To: Bidders for the *Oak Brook Park District- Central Park Improvements*

SUBJECT: ADDENDUM NO. 1 TO THE BIDDING DOCUMENTS FOR:
Oak Brook Park District – Central Park Improvements
Bid Group #1 Bid Packages 1 - 19

Project No. 07-5646-04

QUESTIONS AND ANSWER LOG

SD1.02

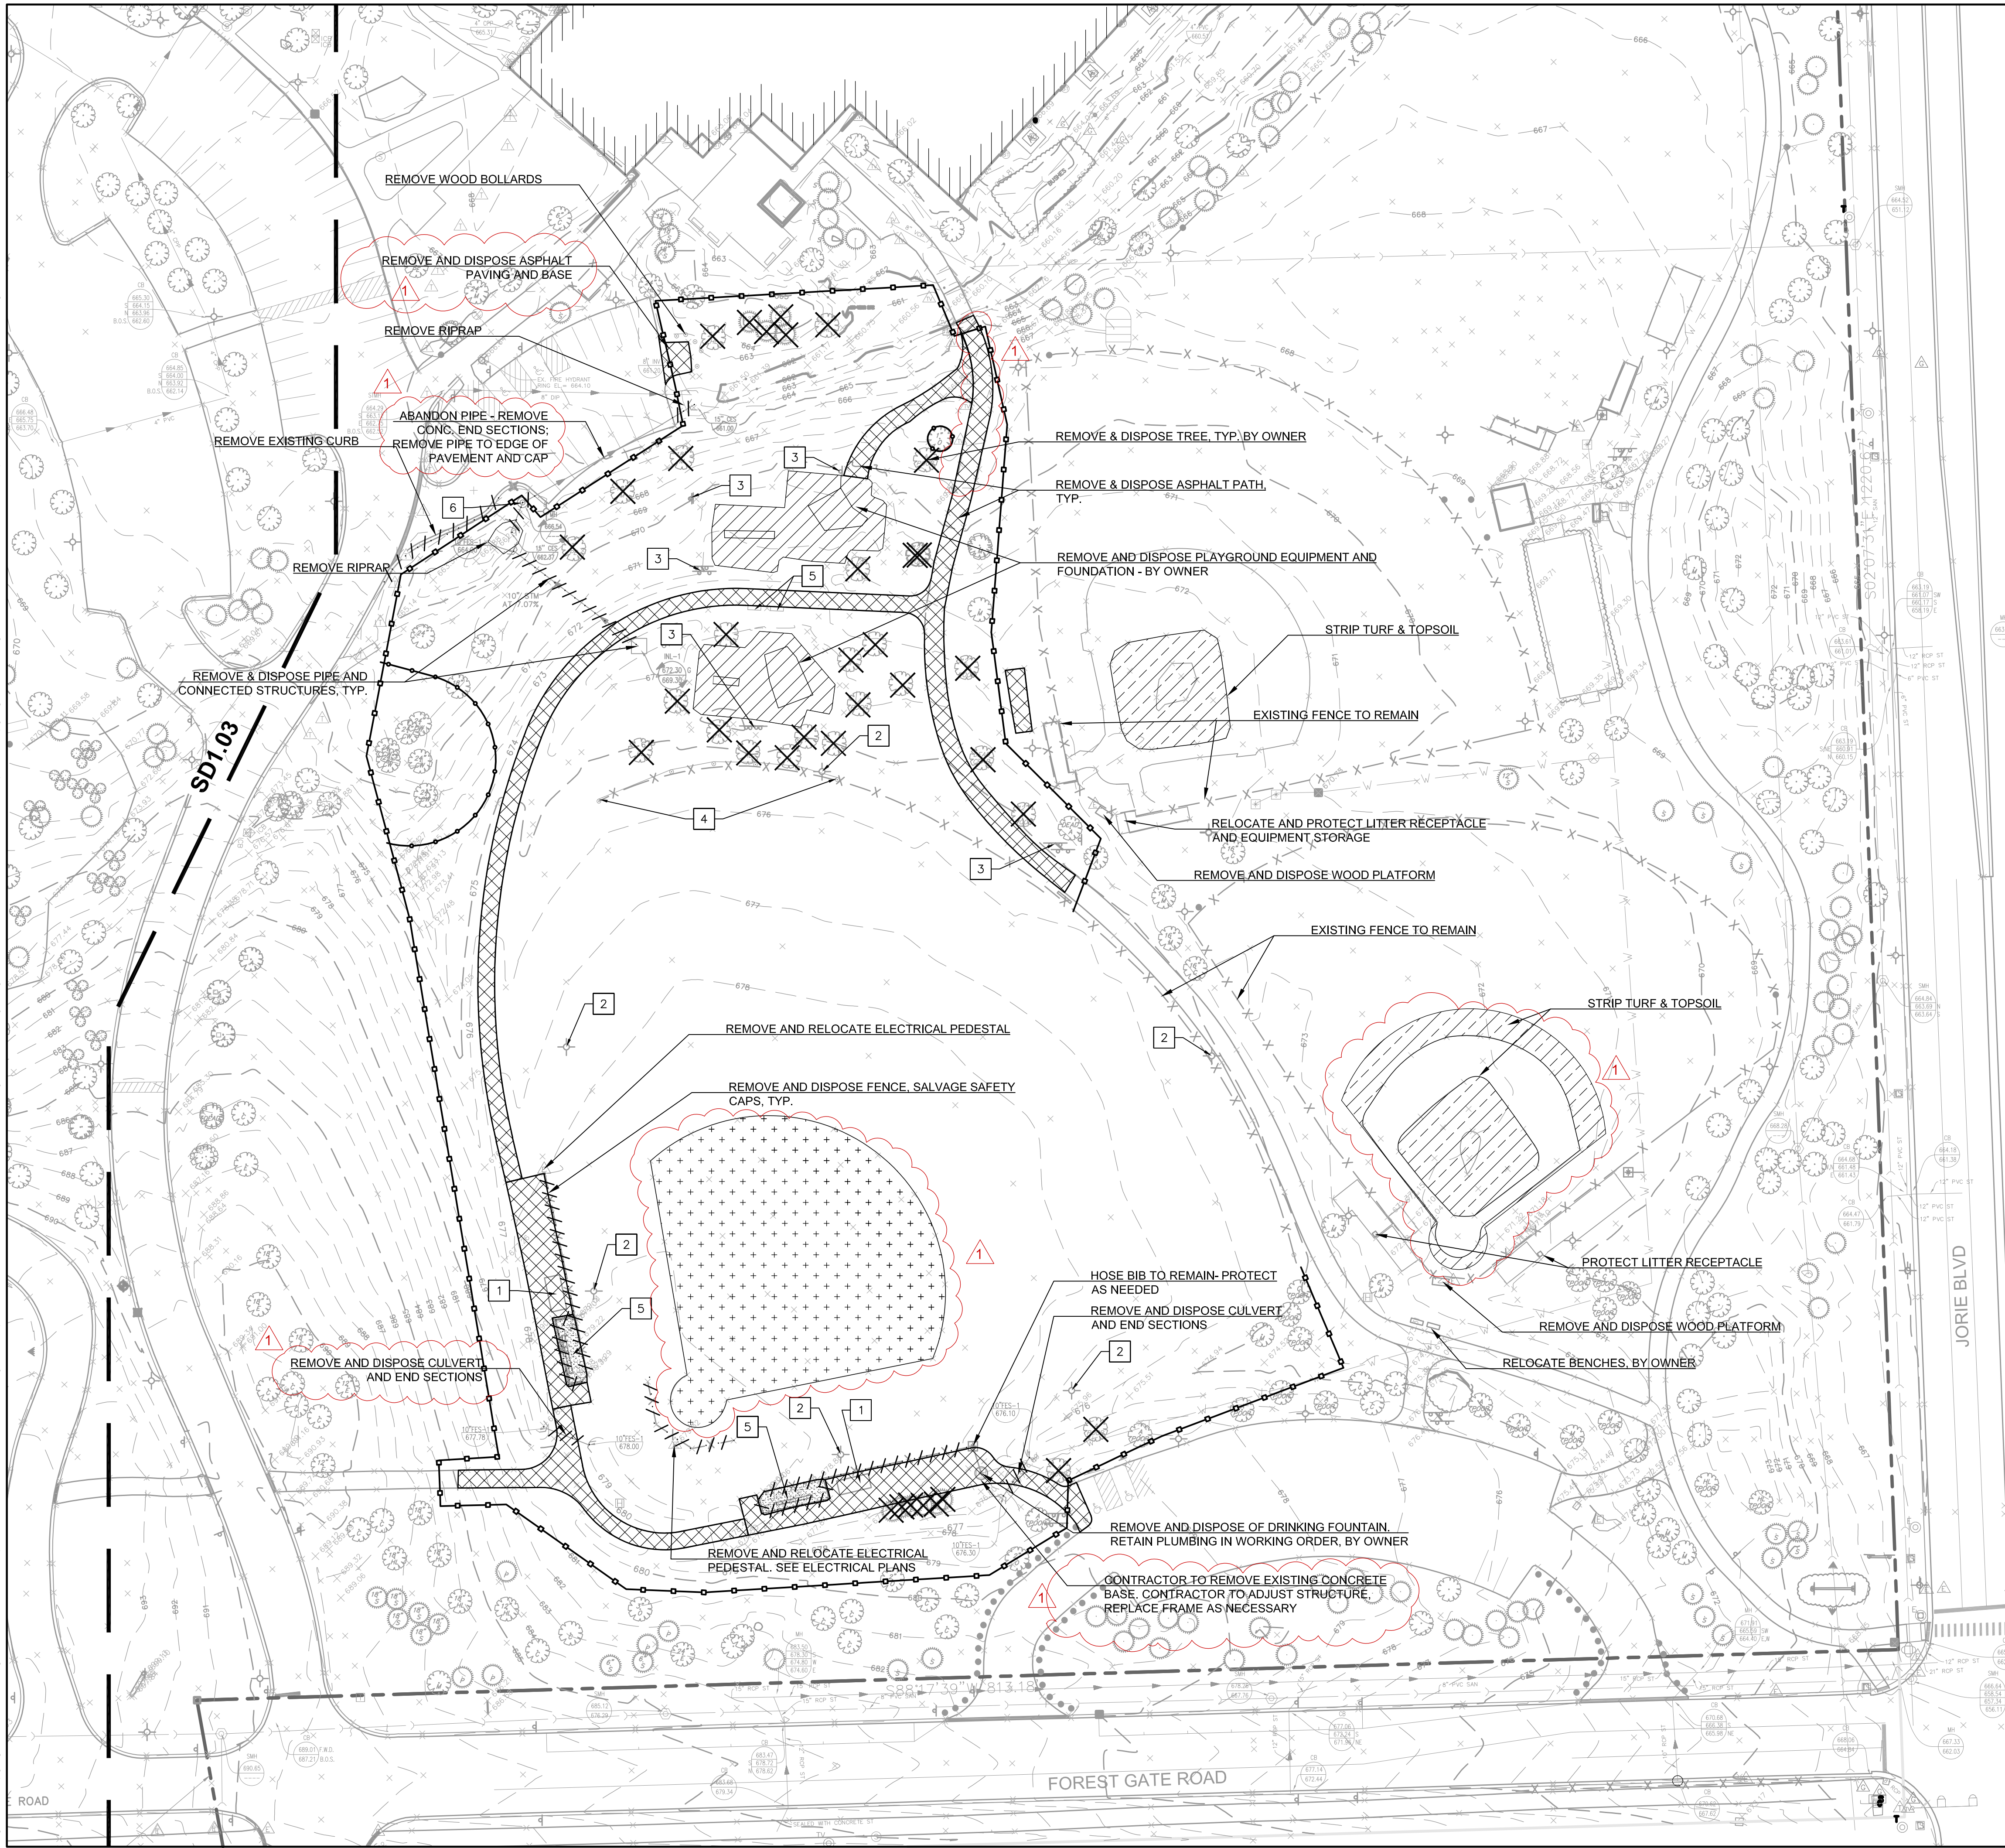
1. Revised note for asphalt paving removal at end of parking to lot indicate removal of base as well.
2. Revised note for abandoning pipe to indicate cutting and removal of pipe to the edge of pavement and removal of concrete end sections.
3. Revised limits of asphalt path removal at north end of path.
4. Revised note for culvert removal at south of the ballfield to indicate removal of flared end sections
5. Revised limits of infield mix removal.
6. Revised limits of turf removal on south east field.

SD2.04

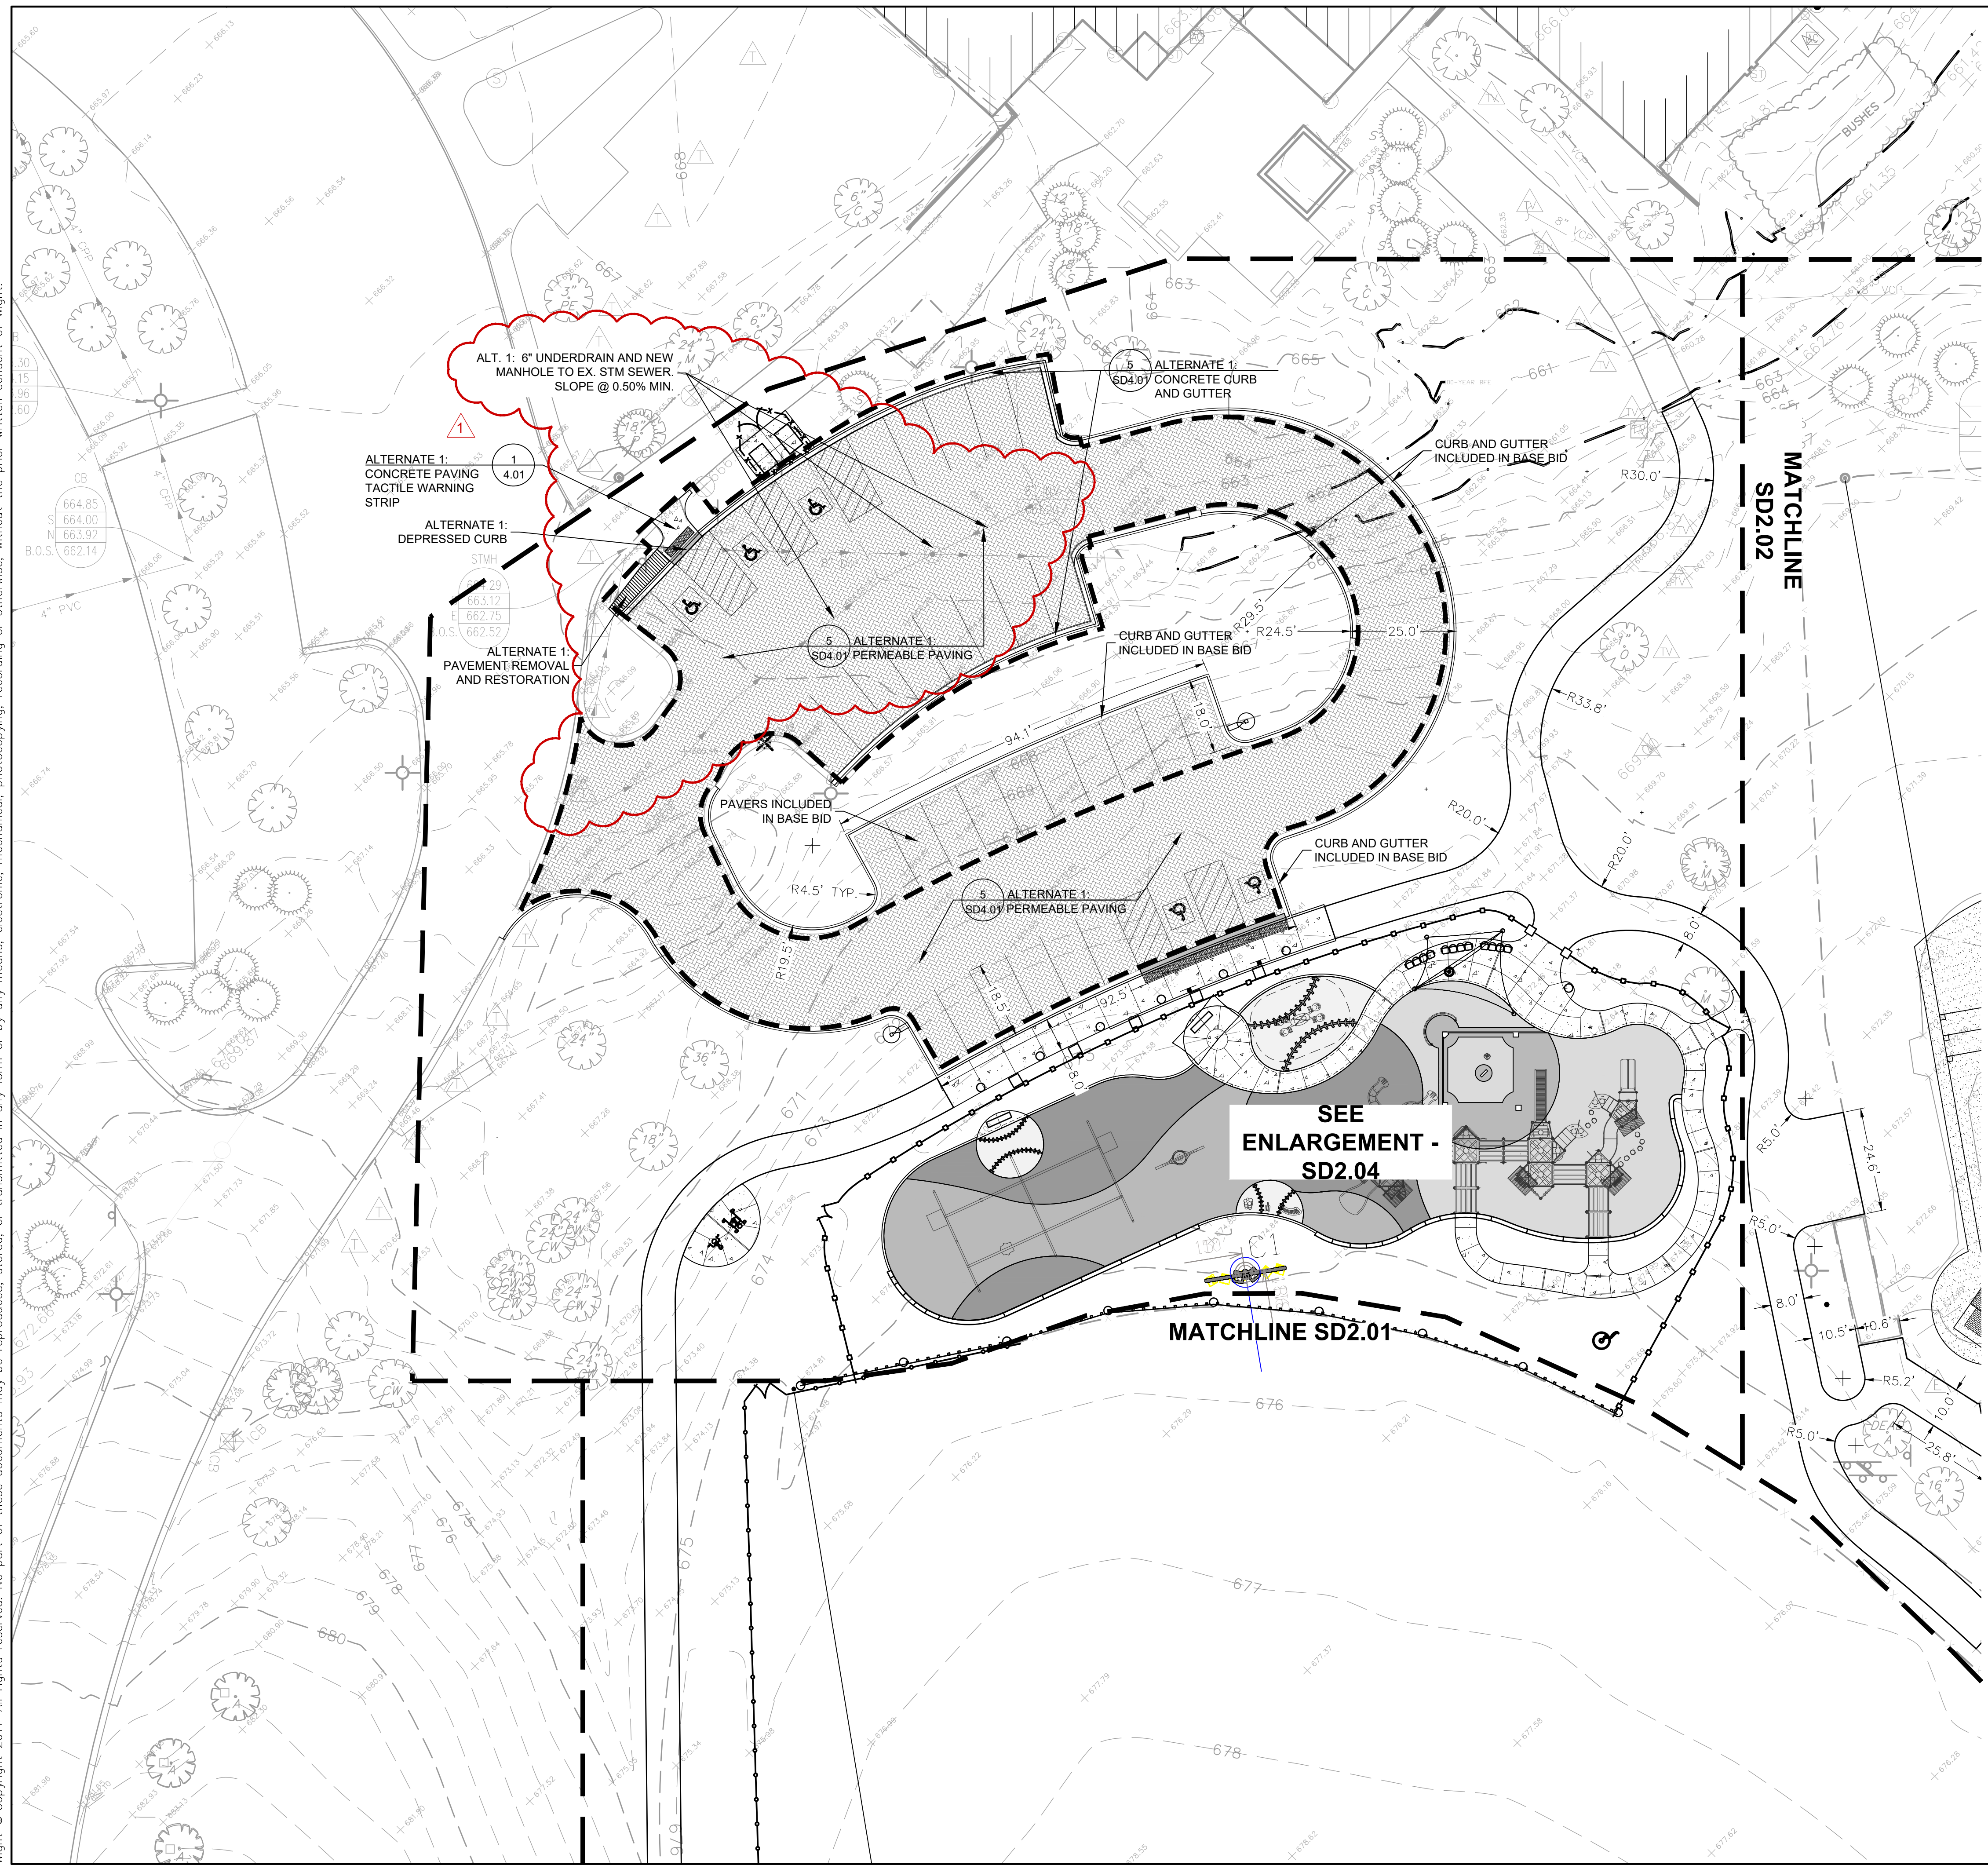
1. Removed 'surface mount' from Concerto musical equipment note. Musical equipment shall be installed according to manufacturer's specifications.

2. Added tag and detail call out for thickened edge walk.

Sheet:
SD2.05

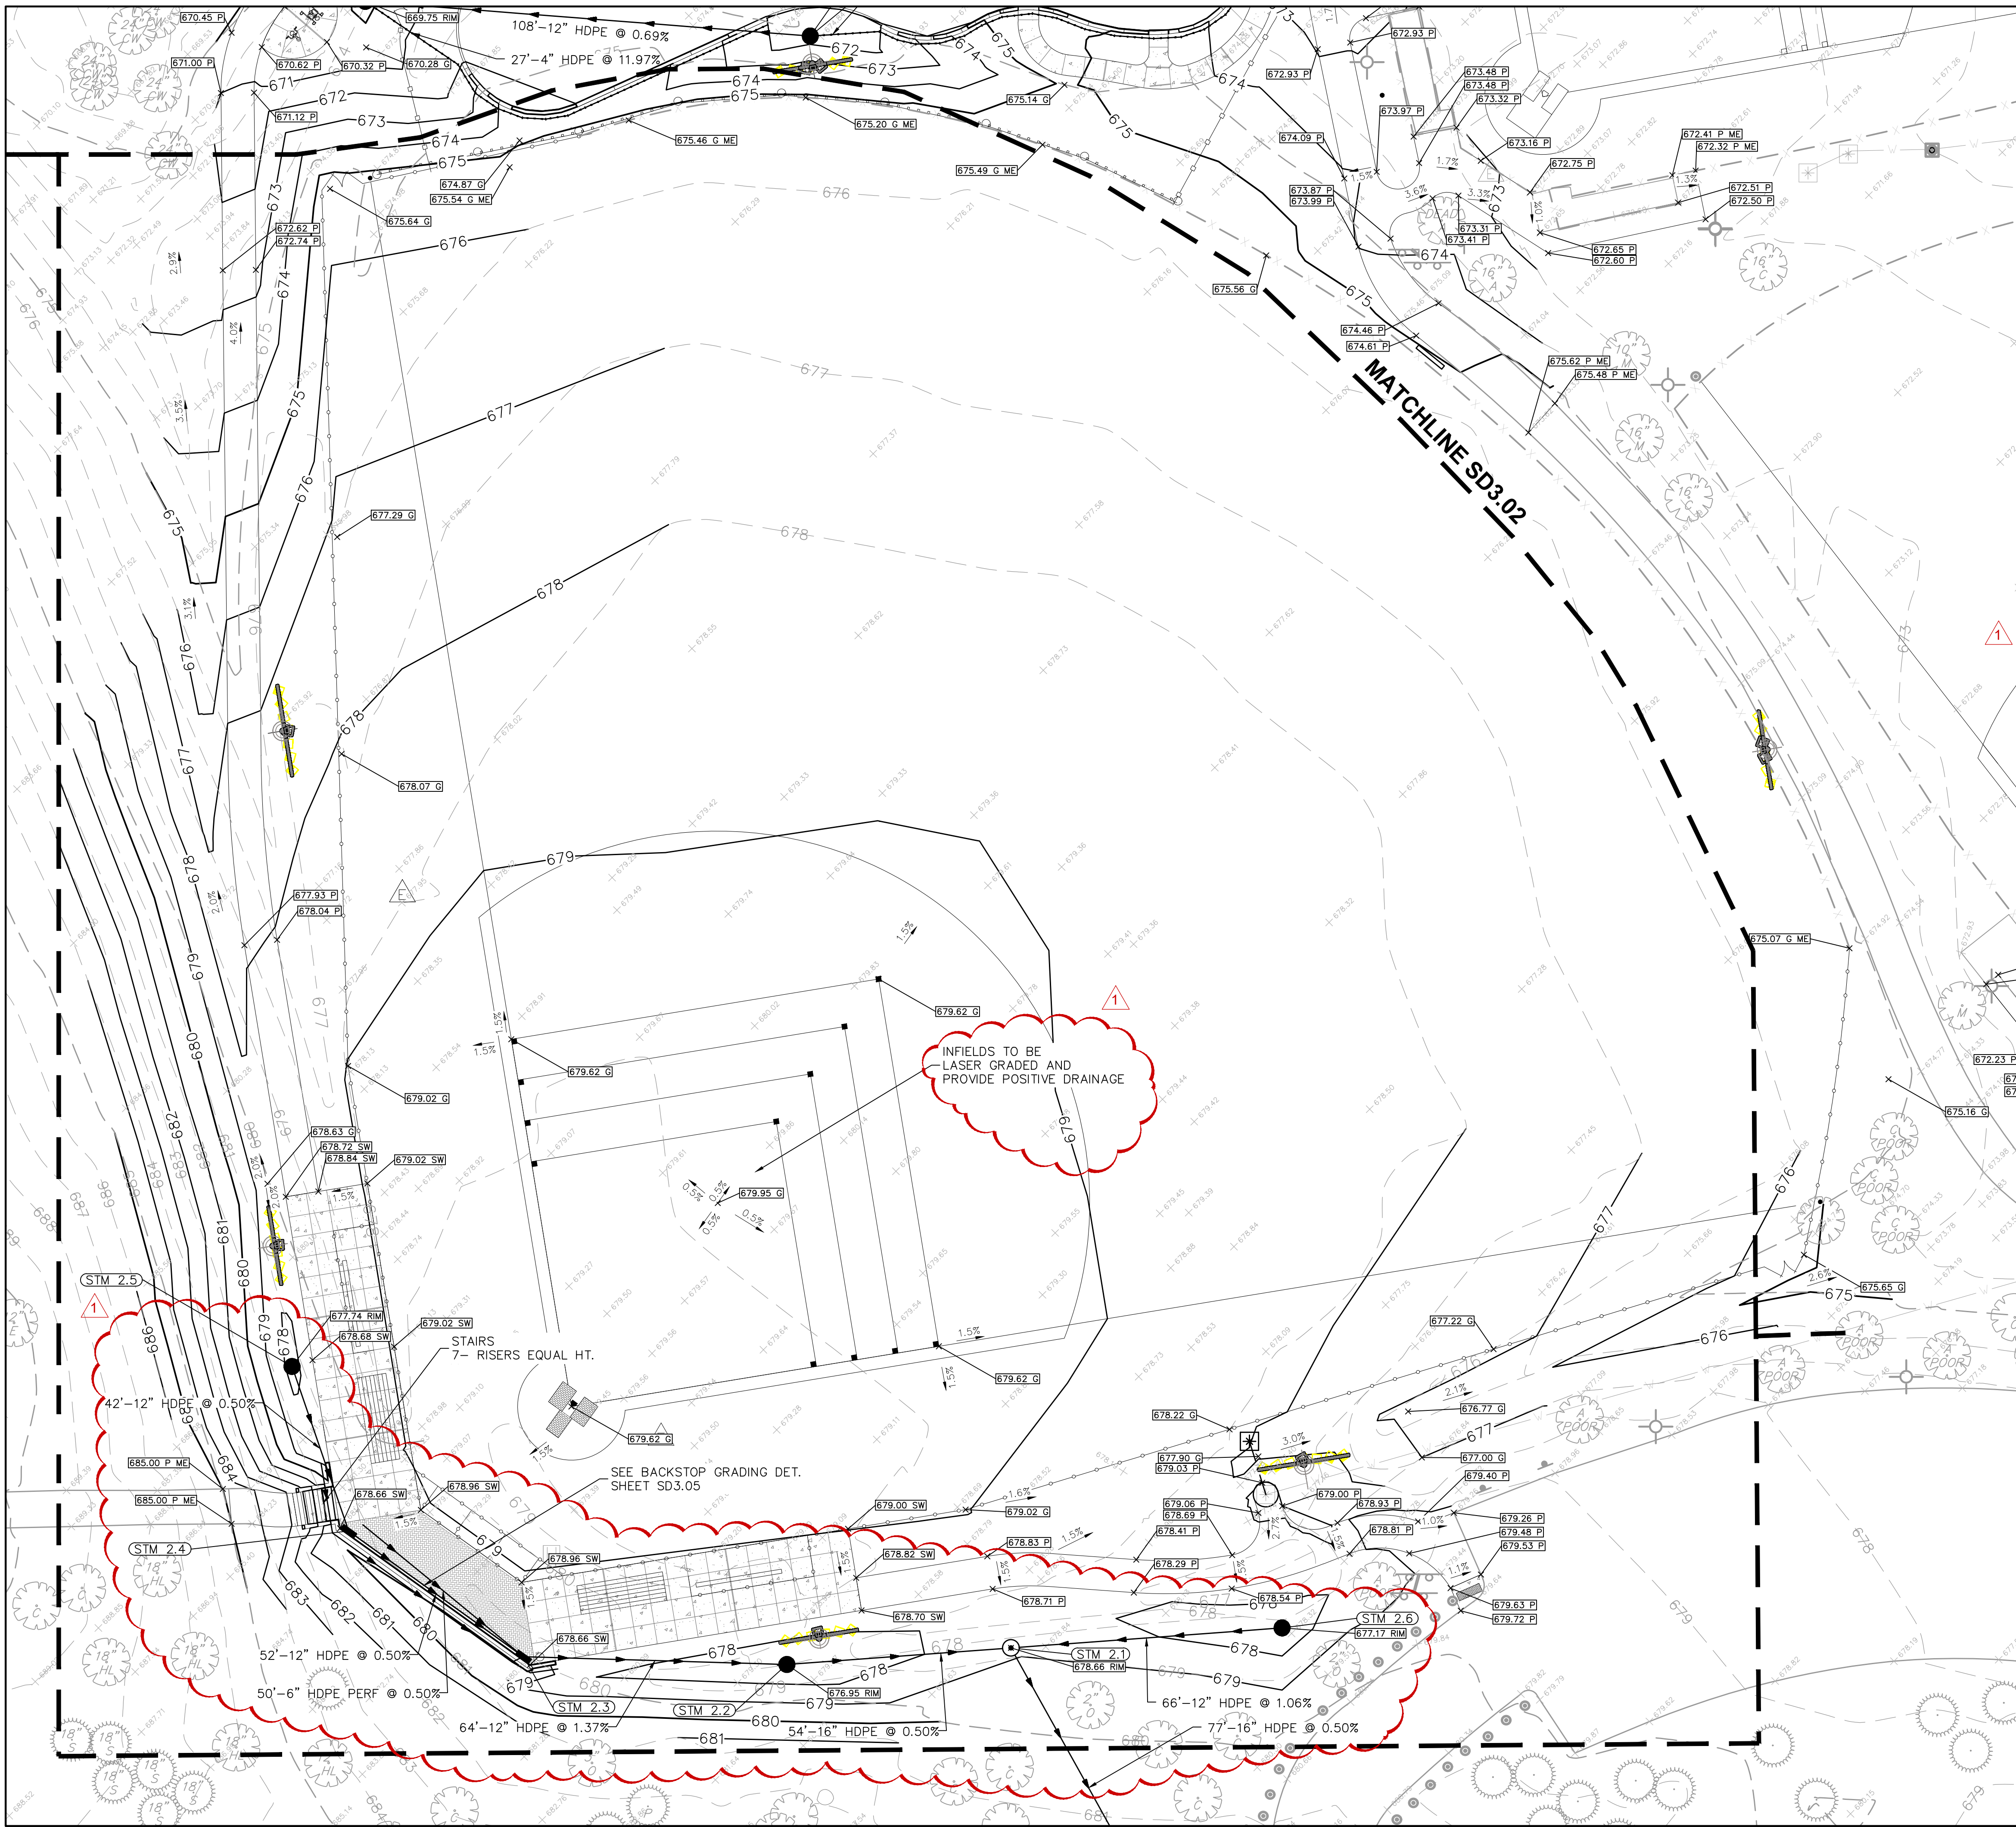
1. Corrected alternate labels
